Planning and Zoning Commission

January 7, 2026 – REGULAR MEETING

- I. P25-205 Development Plan for a Mixed-Use Development at 145 W. Pearl Ave. and 65 S. Glenwood St. (Andrew Bowen)

Meeting Date:	January 7, 2026	Meeting Title:	Planning Commission Regular Meeting
Submitting Department:	Planning Department	Presenter:	Andrew Bowen
Agenda Item:	Development Plan for a Mixed-use Development at 145 W Pearl Avenue and 65 S Glenwood Street (P25-205)	Public Comment:	Yes

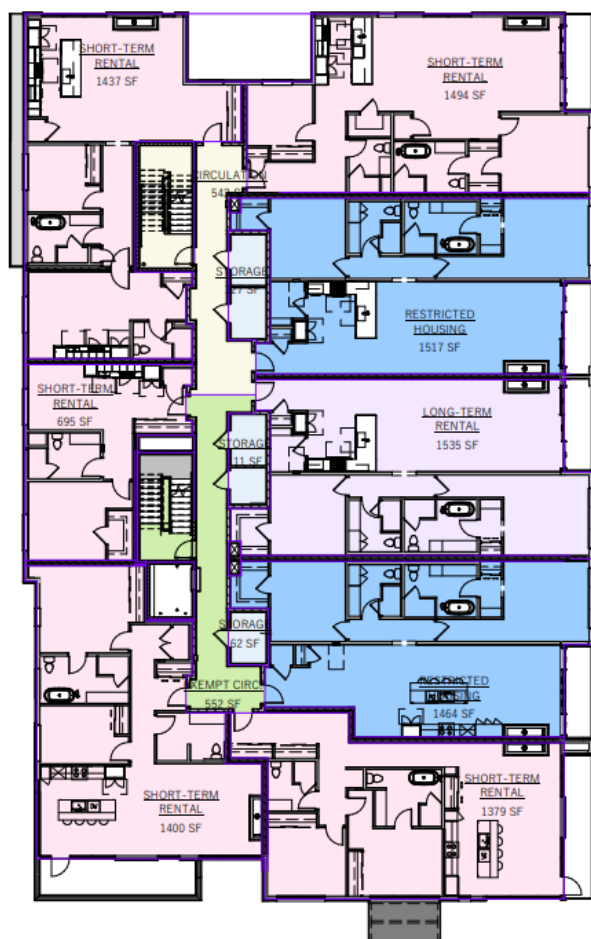
As part of the site planning process, the Applicant proposes removal of four mature spruce trees located on the adjacent Stryk property (155 West Pearl Avenue), with replacement trees to be planted as part of the project. One additional tree not directly adjacent to the subject site will remain and be protected during construction. The trees are proposed for removal due to the anticipated adverse impacts associated with the project's proximity and due to their health and future safety concerns as discussed below. While staff has received email correspondence indicating that Ted Stryk agrees with the proposed removals, a formal written authorization has not yet been provided.

Staff has requested that Steve Bigger a staff member with the Parks and Recreation Department who is also an ISA Certified Arborist look into this issue, but at the writing of the staff report no analysis has been provided. However, in providing comment for the new Teton County Justice Center, Steve Bigger has provided the following determination.

"Transplanting larger spruce is not ideal and typically doesn't have a high level of survivability. The general rule of thumb when transplanting a tree is a year for every inch of diameter to start regaining its vigor and health. So an 8" tree needs 8 or so years to fully acclimate to the new site. Growth from a nursery tree will likely outgrow a transplanted tree over time."

Further he recommends *"deciduous trees if you want height and quicker growth. Columnar Aspens are a good example. In short, a larger spruce is not necessarily better in this case for long-term viability. Go with nursery stock or try deciduous installs."*

Does the Planning Commission support the Applicant's proposal to remove the large spruce trees located on the adjacent property to accommodate the proposed building's proximity to the western property line?

PEARL STREET CURB & SIDEWALK PROFILE

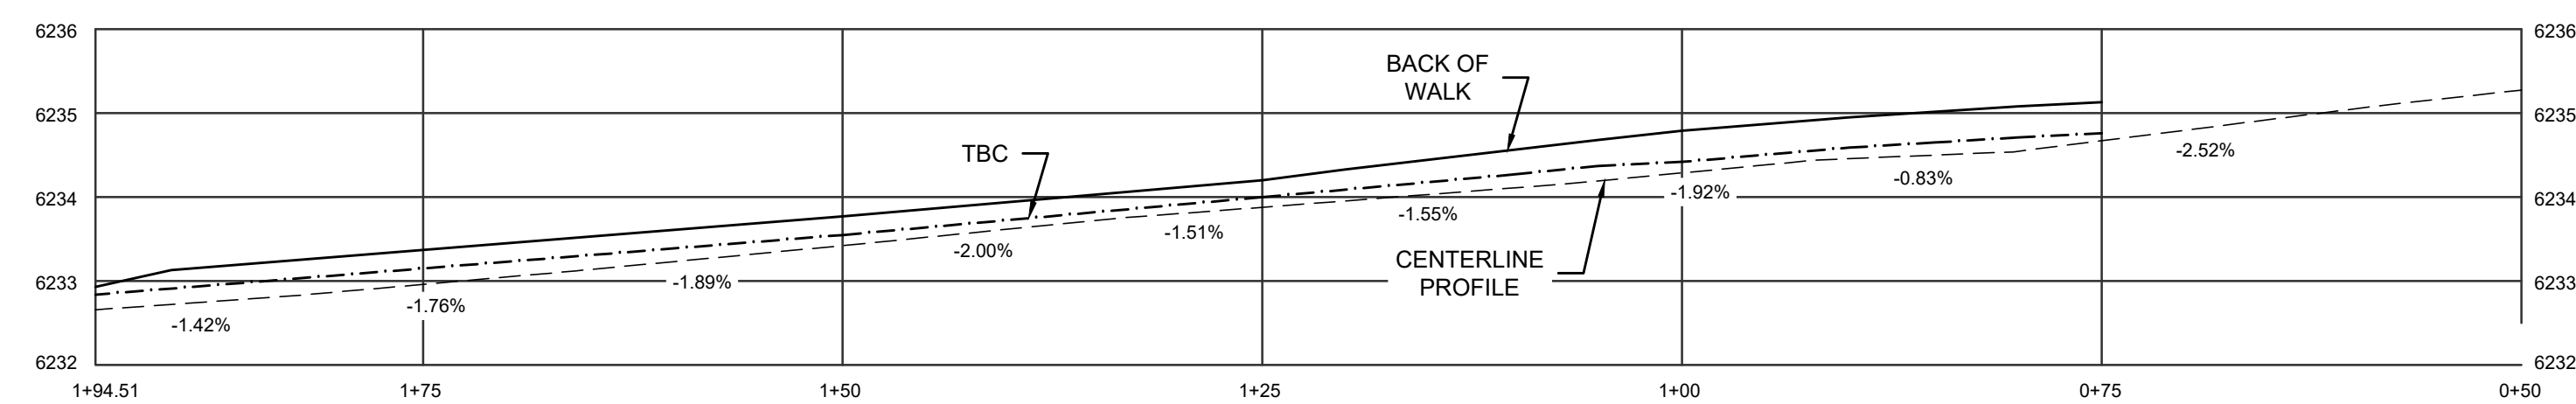
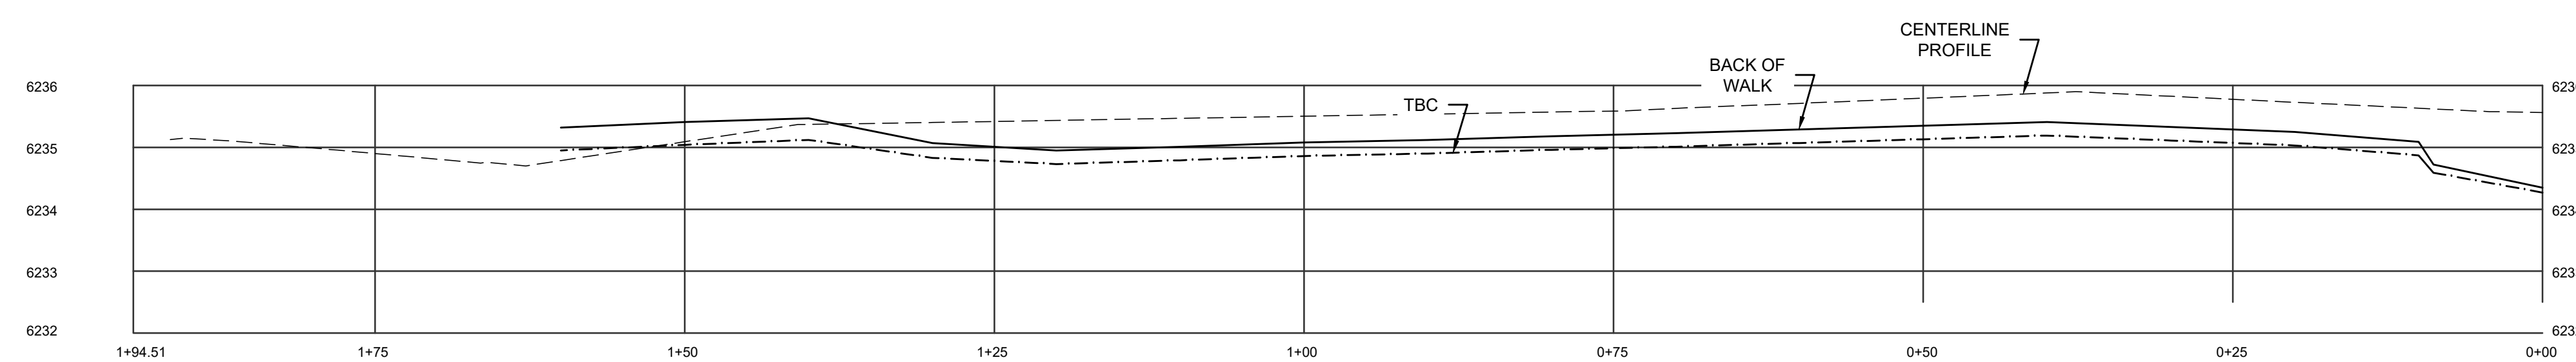
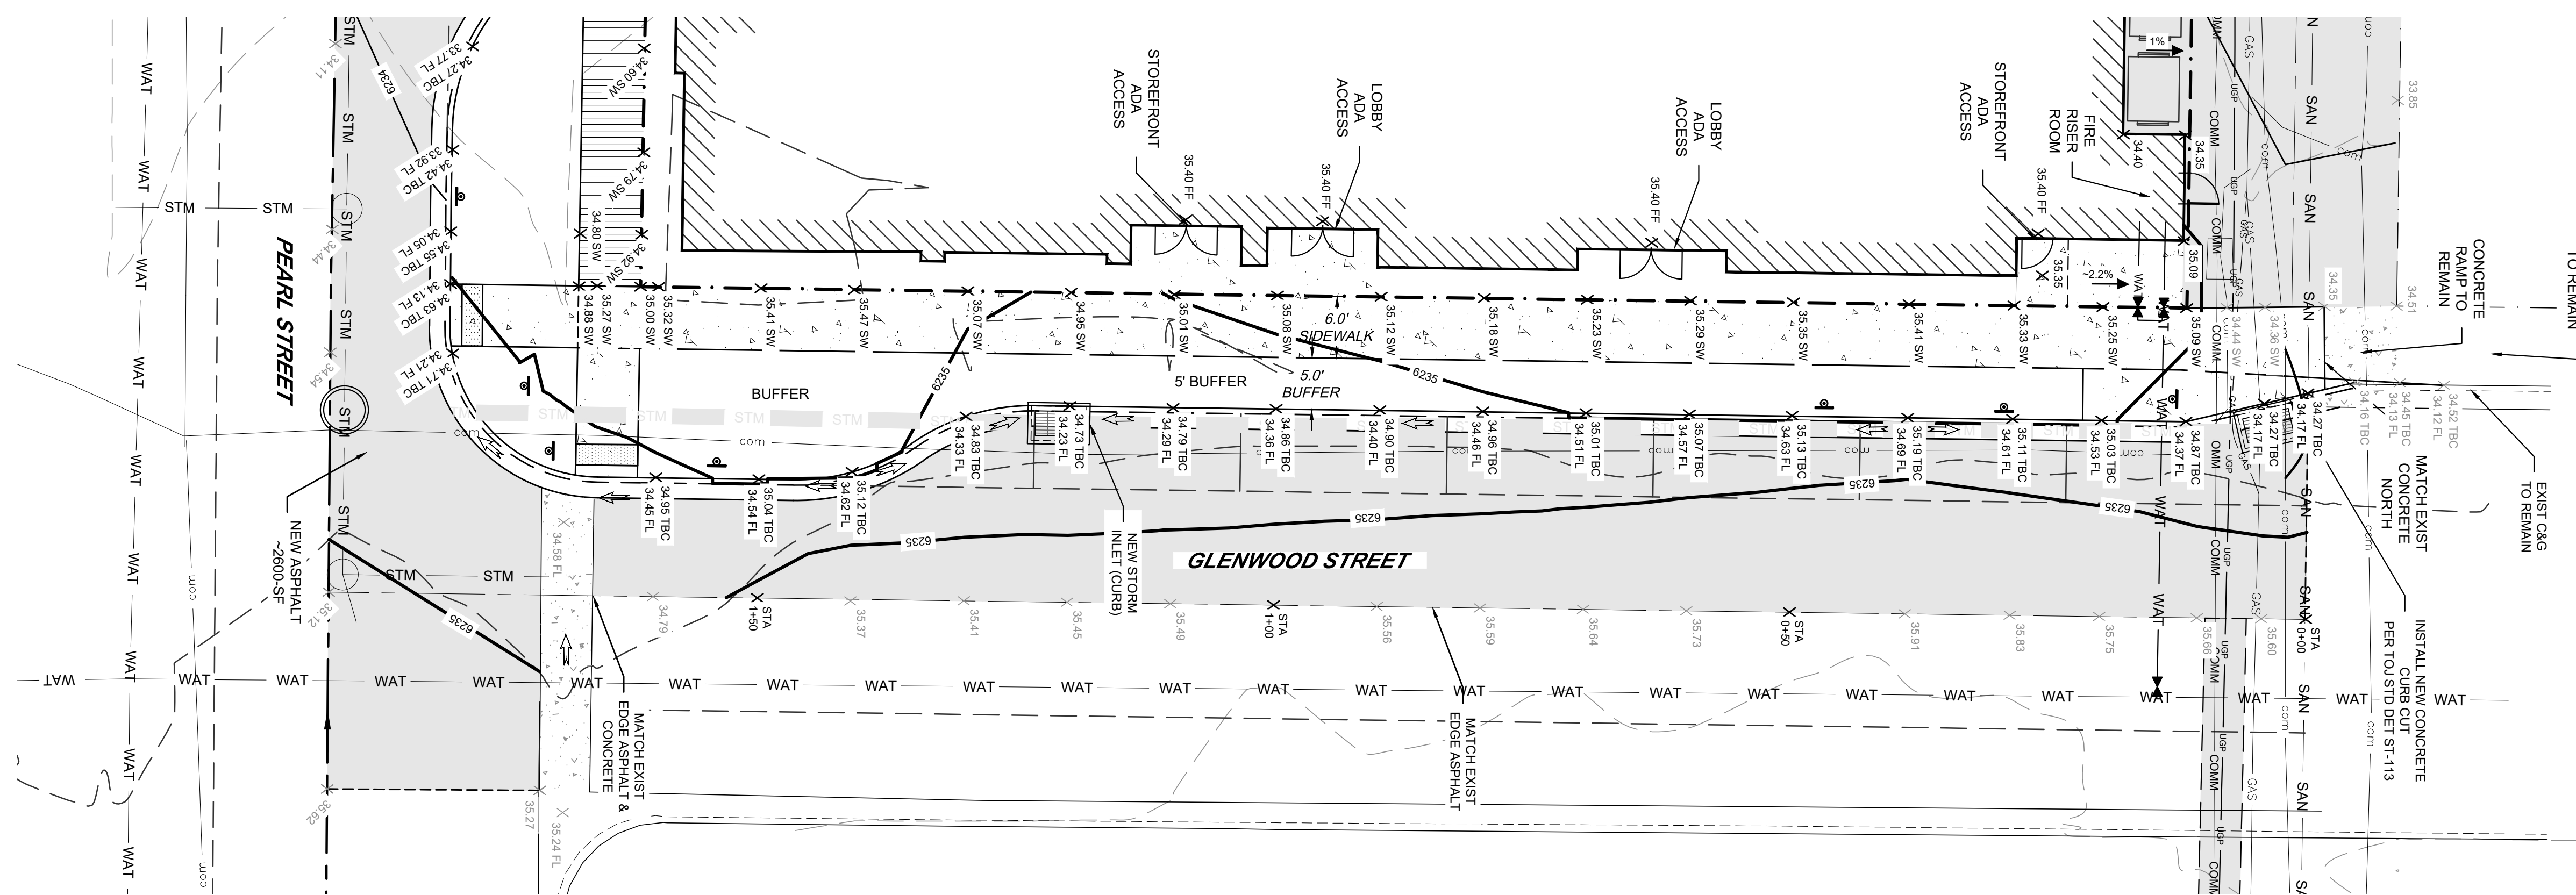
12. Show how new building and grading within private property will tie into the public right-of-way. Do not use sidewalk/buffer area to make up grading for private project. Include profile drawing(s) of existing and proposed top back of curb, flowline, and back of sidewalk.

Responses: Grading plan (draft) provided. No grading proposed on adjacent properties.
